## RESPONSE TO REQUEST FOR ADDITIONAL INFORMATION

### APR1400 Design Certification

Docket No. 52-046

RAI No.: 182-8160  
SRP Section: 03.07.01 – Seismic Design Parameters  
Application Section: 3.7.1  
Date of RAI Issue: 08/31/2015

Figure 19 Comparison of PSD between Full Duration and Truncated Duration for CSDRS-EW Compatible Time History

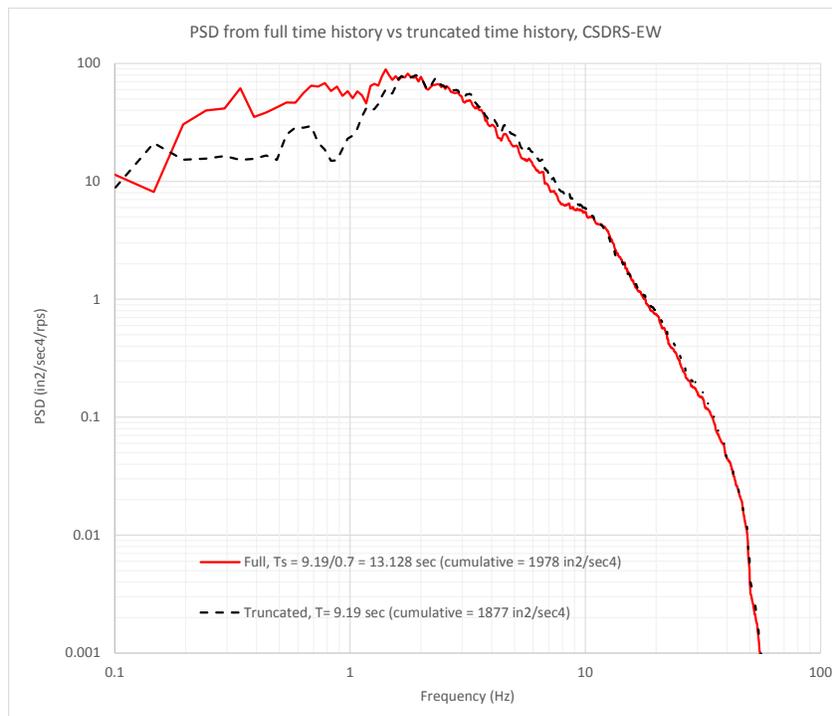
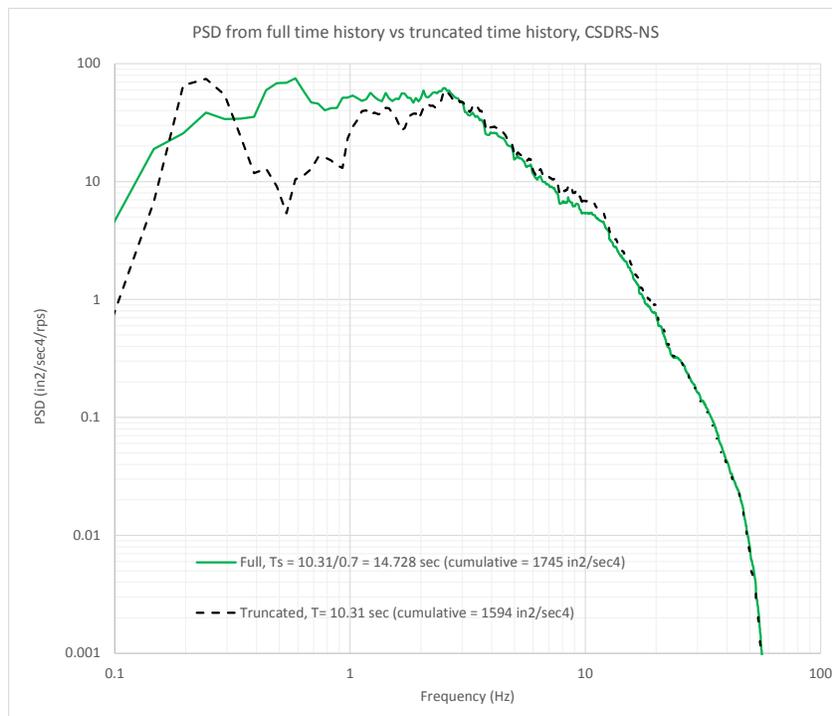
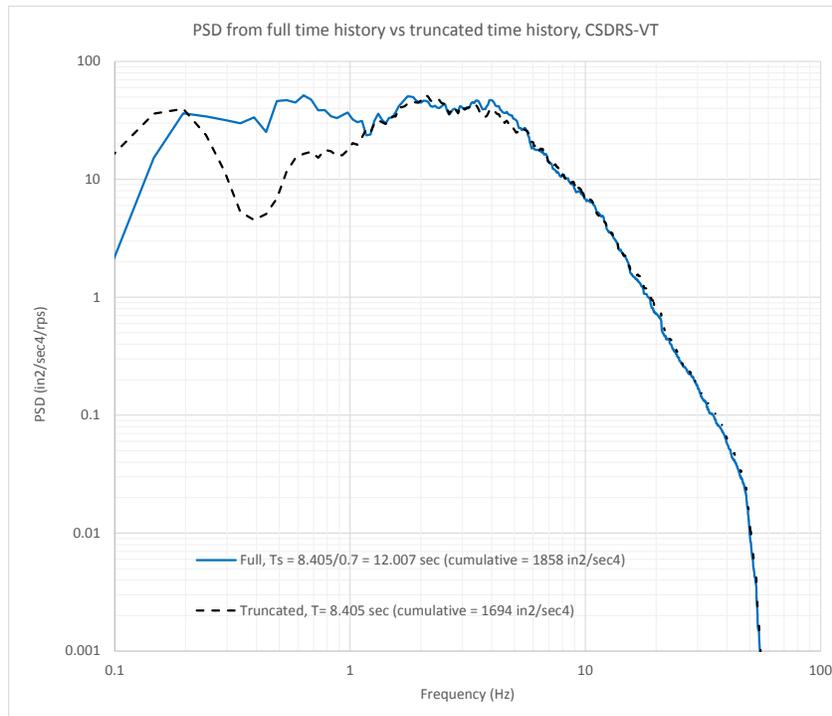
**a) Explain the method used to estimate PSD for the CSDRS time histories**

In DCD Section 3.7.1.1.2, the PSDs of the design acceleration time histories are compared to the corresponding target PSD. However, the method to estimate the PSD from an acceleration time history is not provided. Therefore, the applicant is requested to provide a description of the method for the PSD estimation and justify any difference of the method as compared to the guidance provided in SRP 3.7.1. The provided information should include the definition of the strong motion duration, portion of the time history used to compute the Fourier spectra, PSD smoothing, and any normalization parameters used in Fourier transform and PSD calculation.

The full time histories are the time histories of full duration from 0 to 20.48 seconds. The truncated time histories are the time histories truncated from the time  $T_{5\%}$  to the time  $T_{75\%}$  of the Arias Intensity plots. Using these definitions, the 5% to 75% truncated equivalent stationary duration designated as  $T_{(75\%-5\%)}$  is computed as  $T_{(75\%-5\%)} = T_{75\%} - T_{5\%}$ . Similarly, the 0% to 100% extended equivalent stationary duration designated as  $T_{(100\%-0\%)}$  is computed as  $T_{(100\%-0\%)} = T_{100\%} - T_{0\%} = (T_{75\%} - T_{5\%}) / (75\% - 5\%) = T_{(75\%-5\%)} / 0.7$ . The time histories, the Fourier amplitudes, PSD and smoothed PSD for time histories of full duration and truncated time histories are shown in Figures 1 through 18, respectively. The comparisons of PSDs for CSDRS compatible time histories between full duration and truncated duration are shown in Figures 19 through 21.

The results that the time-history PSDs computed using the full-duration time histories and the corresponding 0% to 100% extended equivalent stationary duration  $T_{(100\%-0\%)}$

are very consistent and comparable with the time-history PSDs computed from the 5% to 75% truncated time histories and the corresponding truncated 5% to 75% equivalent stationary duration  $T_{(75\%-5\%)}$  for the frequency range from about 2 to 50 Hz. These results validate the procedure of using the full-duration time histories and the corresponding 0% to 100% extended equivalent stationary duration  $T_{(100\%-0\%)} = T_{(75\%-5\%)} / 0.7$  to compute the time-history PSDs, giving the resulting PSDs so computed being very equivalent and comparable to the time-history PSDs computed using the 5% to 75% truncated time histories and the corresponding truncated 5% to 75% equivalent stationary duration  $T_{(75\%-5\%)}$  for the frequency range from 2 to 50 Hz.

For the lower frequency range below about 2 Hz, i.e., for the low frequency range from 0.2 to 2 Hz, the time-history PSDs computed using the full-duration time histories and the 0% to 100% extended equivalent stationary duration  $T_{(100\%-0\%)} = T_{(75\%-5\%)} / 0.7$  deviate from the time-history PSDs computed using the 5% to 75% truncated time histories and the corresponding 5% to 75% equivalent stationary duration  $T_{(75\%-5\%)}$  because the truncation of the full-duration time histories to a shorter-duration time histories affects the long-period (low-frequency) motion contents and amplitudes as indicated by the comparisons of the time-history response spectra for the full-duration and truncated time histories. The longer the truncated time-history duration the lower the validity frequency range of the computed truncated time-history PSDs. As shown in Figures 22 through 24, the response spectra of the truncated time histories fall below the corresponding full-duration time-history response spectra, which also fall below the corresponding target CSDRS in the low frequency range from 0.2 to 2 Hz as also indicated from the comparisons of the computed PSDs in the same low frequency range as shown in Figures 19 through 21.

From the results shown in above, it can be concluded that the use of full-duration time history and the corresponding 0% to 100% extended equivalent stationary duration  $T_{(100\%-0\%)} = T_{(75\%-5\%)} / 0.7$  to compute the time-history PSD is a convenient and valid procedure to generate the time-history PSDs and the results so obtained are valid for a wider frequency range from the low frequency of 0.2 Hz to the high frequency of 50 Hz.
